DPC-NE-2005P-A

**DUKE POWER COMPANY
THERMAL-HYDRAULIC
STATISTICAL CORE
DESIGN METHODOLOGY**

SUBJECT: ACCEPTANCE FOR REFERENCING OF THE MODIFIED LICENSING TOPICAL
REPORT, DPC-NE-2005P, "THERMAL-HYDRAULIC STATISTICAL CORE DESIGN
METHODOLOGY" (TAC NO. M85181)

SAFETY EVALUATION BY THE OFFICE OF NUCLEAR REACTOR REGULATION
RELATING TO THERMAL-HYDRAULIC STATISTICAL CORE DESIGN METHODOLOGY
TOPICAL REPORT DPC-NE-2005P
FOR
THE DUKE POWER COMPANY

REVISED SCD FLOWCHART

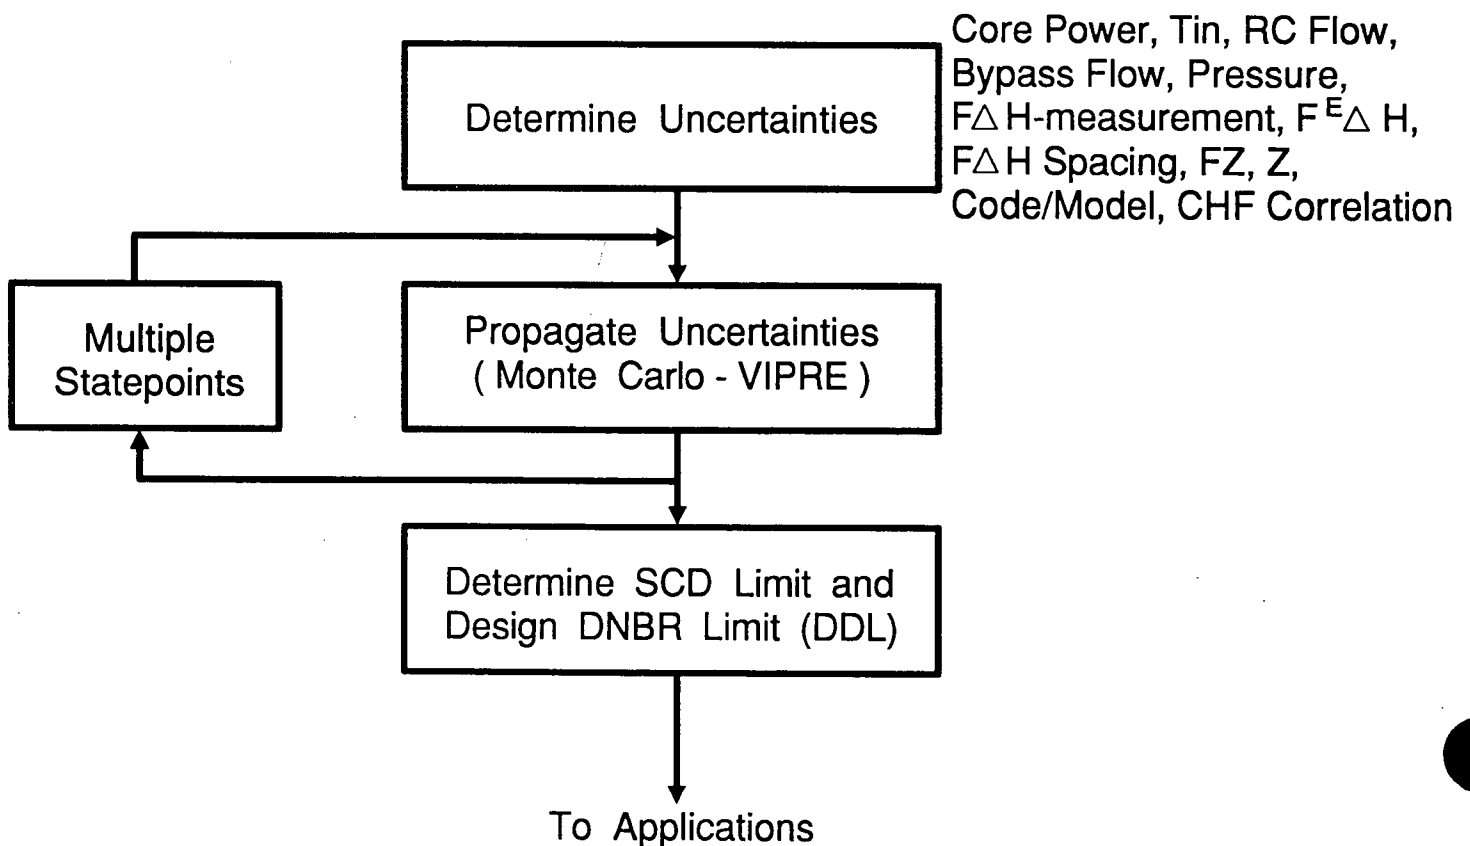
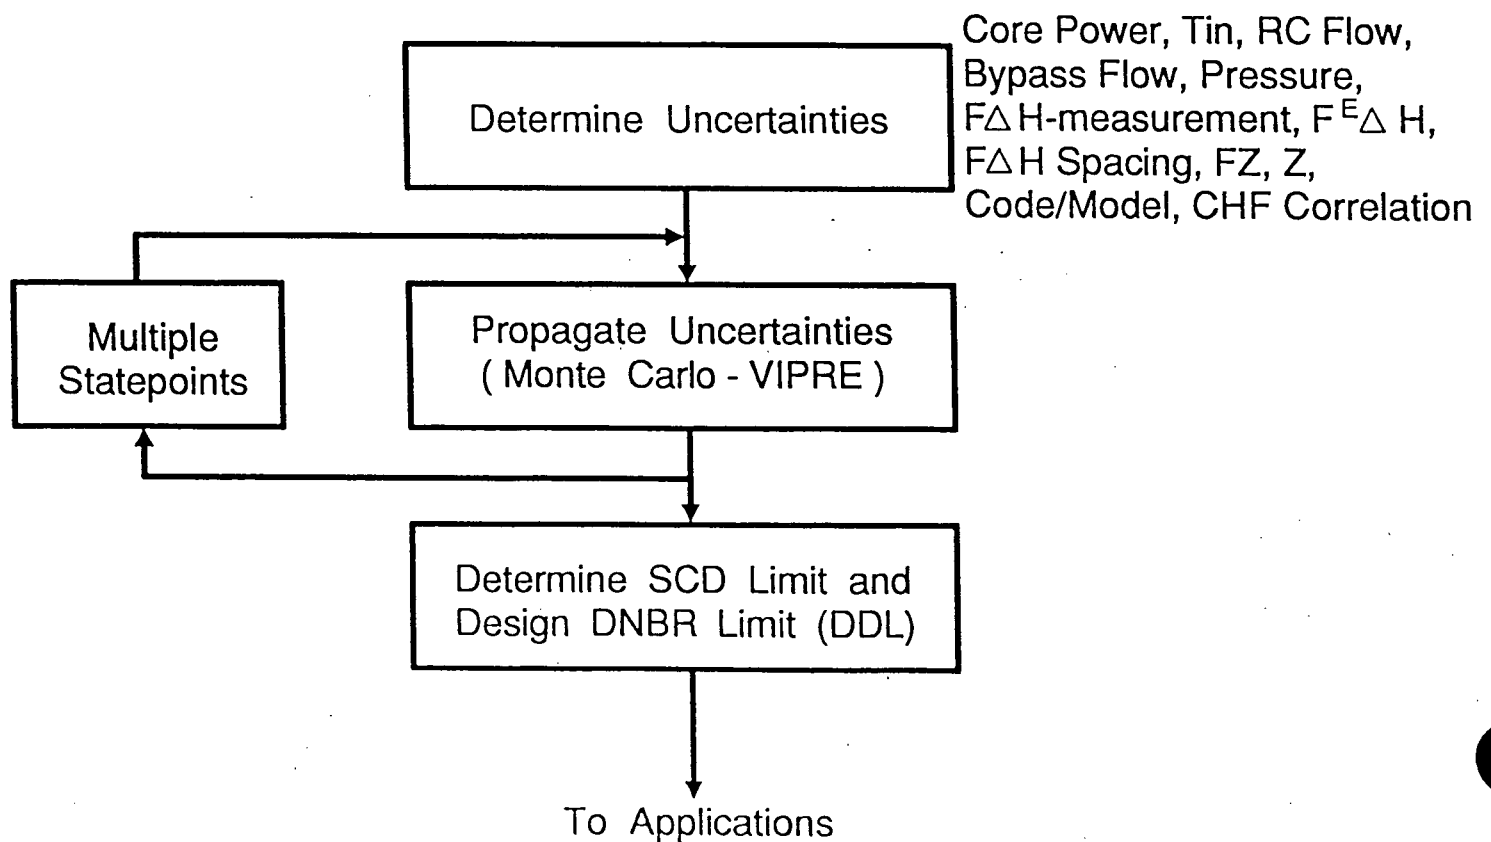
Additionally, the flow chart in Figure 2 also contains a typo. The Propagate Uncertainties box should have the words (Monte Carlo - VIPRE) underneath. The RSM is not used at all in the revised method described by the report. A corrected page 30 is also included.
